# **Details of Representations**

# **Application Summary**

Application ID	24024441
Proposal	Two-storey residential flat building comprising community housing dwellings (28) and supported accommodation premises (2) and demolition of buildings including one Representative Building with associated car parking and landscaping
Location	105 GIBSON ST BOWDEN SA 5007, 12 MARKET PL BOWDEN SA 5007, 16 MARKET PL BOWDEN SA 5007, 18 MARKET PL BOWDEN SA 5007, 2 -10 MARKET PL BOWDEN SA 5007

Figure 1

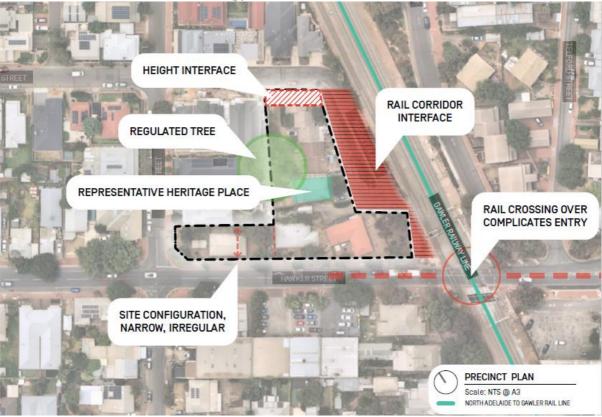
The architectural plans only highlight one tree on the site which has been labelled as 'Regulated'. However this status is incorrect, and there are additional trees which are either Regulated or Significant as per the *Planning, Development and Infrastructure Act 2016.*Trees defined as Regulated or Significant should be preserved *if* they meet the relevant environmental criteria within the *PDI Regulations 2017* and desired Performance Outcomes.

Image 1. Screen capture from the Greater Adelaide Regional Plan heritage overlay for the Bowden and proposed Uniting on Hawker Site with star denoting proposed development site.<sup>1</sup>

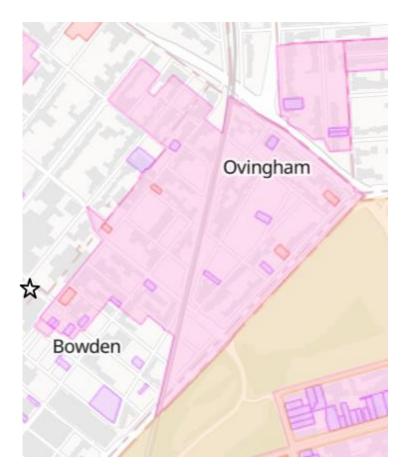
The Planning and Design Code emphasises that any new development must be contextual—carefully responding to its surroundings and contributing positively to the character of the area. This part of Bowden is recognised for its historically significant character, defined by small, narrow allotments and predominantly single-storey, detached or semi-detached workers' cottages, bungalows, and austerity homes.

Image 3. Screen capture of the Google Maps distance from the proposed development to the Ovingham Railway Station

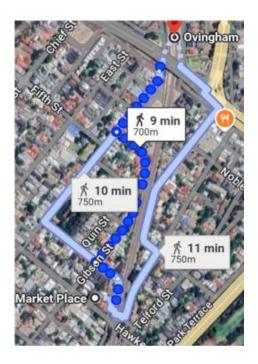
Access to this station is also a concern. The shortest route involves a cut-through under Park Terrace, an area that raises significant safety concerns. As a female cyclist familiar with this route, I can attest to the poor visibility and its frequent use as a dumping ground for items left by people sleeping rough. The area is also marred by graffiti. Given these conditions, I avoid walking through this area alone, even during the day. It is reasonable to assume that women, particularly those aged 55 and over, would feel similarly unsafe navigating this route.

While the Ovingham Railway Station offers services throughout the day and on weekends, these are not frequent. Trains run every 30 minutes on weekdays, reducing to hourly on weekends and public holidays, which falls short of the high-frequency definition of every 15 minutes (Appendix 1). Furthermore, the Ovingham Railway Station is 700 metres from the proposed development site—well beyond the <400 metre benchmark for convenient public transport accessibility.

Image 4. Screen capture of the Google Maps distance from the proposed development to the Bowden Railway Station.

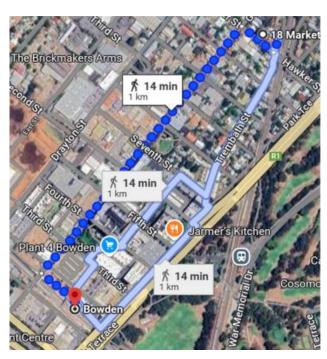
Although Bowden Railway Station does provide higher-frequency services, appropriate for the high-density development surrounding it, the actual walking distance to this station is closer to 1 kilometre, not the 785 metres claimed. Given these factors, it is reasonable to expect that residents will rely more heavily on private vehicles for essential trips, such as grocery shopping and larger outings.
